Report to Planning and Environment Committee

To: Chair and Members
Planning & Environment Committee
From: George Kotsifas P. Eng.,
Deputy City Manager, Planning and Economic Development
Subject: Anast Holdings Inc.
257-263 Springbank Drive
Public Participation Meeting
Date: January 10, 2022

Figure 3: Area of loop to be deforested under plan.

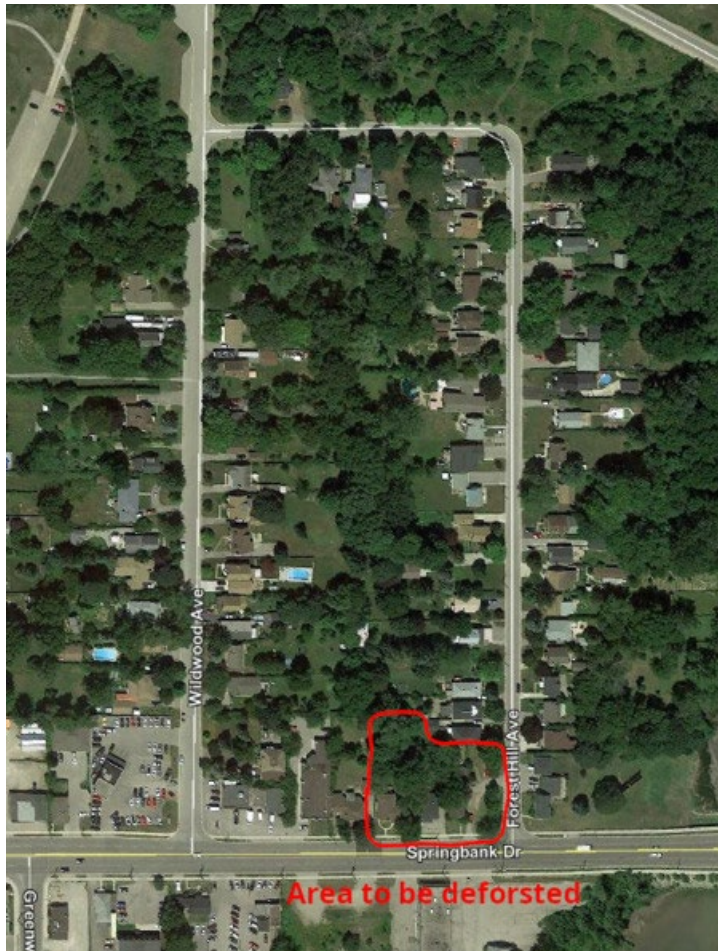
In contrast to this, the proposed plan is to destroy all the mature interior trees and replace them with a small-shrub delimited parking lot that extends right up to the adjacent residential units on all sides. As seen in the figures, this will deforest the south-east chunk of the loop. The only tree to be preserved is one city tree on the north-east corner of the far east lot, and the only replacement trees are to be a few city trees on the perimeter road allowances. At some point, with road expansions (Springbank Dr. will require significant widening to bring it in line with Urban Corridor street's vision in the Mobility Section), these trees will likely go too.

Figure 10: Site plan overlay with R9-7 setback regulations (Zoning By-law Table 13.3)

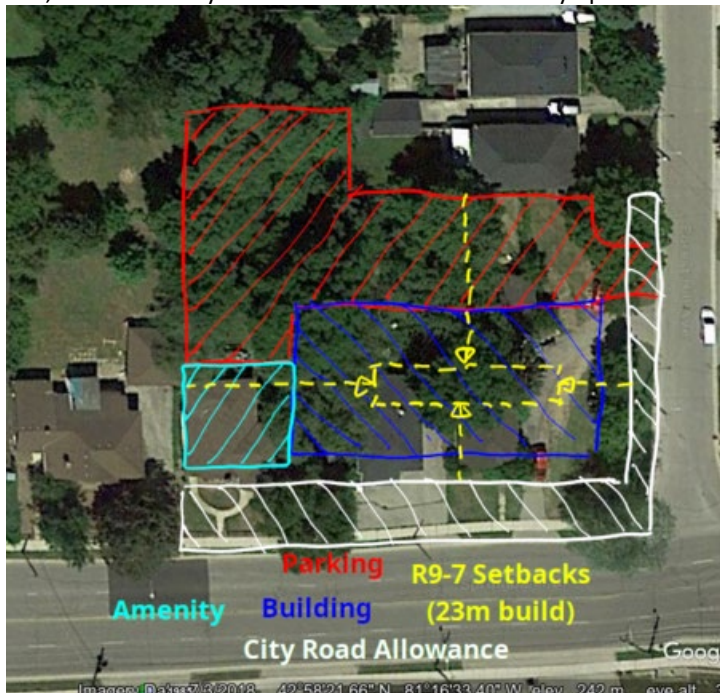
While it isn't yet clear how the Urban Corridor type place will be recognized with respect to zoning requirements (part of why approving this now under the Urban Corridor vision is jumping the gun), the proposal is to for the current R9-7 designation. R9-7 is the highest density form of the R9 medium and higher density designations. This is to be contrasted with the aforementioned Urban Corridor vision of place appropriate moderate levels of intensity, with lesser levels along the primarily residential segments lacking large floor space.[826,840] Nonetheless, we have tabulated the setback requirements given in Table 13.3 of the city's Zoning By-law for an R9-7 zoning abutting a R1 or R2 residential zone in the following table and overlaid them with the site plan onto satellite imagery.

lighting impacts of the parking lot also needs addressing.[278,279,745] The parking precludes on-site garbage pickup under the Site Plan Control By-law (garbage trucks have a 12m centreline turning radius and they are not to have to backup), so large bins will have to be wheeled out to the curb for collection once or twice a week, negatively impacting the adjacent lots and neighbourhood character. Nor is it clear how snow removal will work with no free space (e.g., where will it be piled, where will residents park while it is being cleared)?
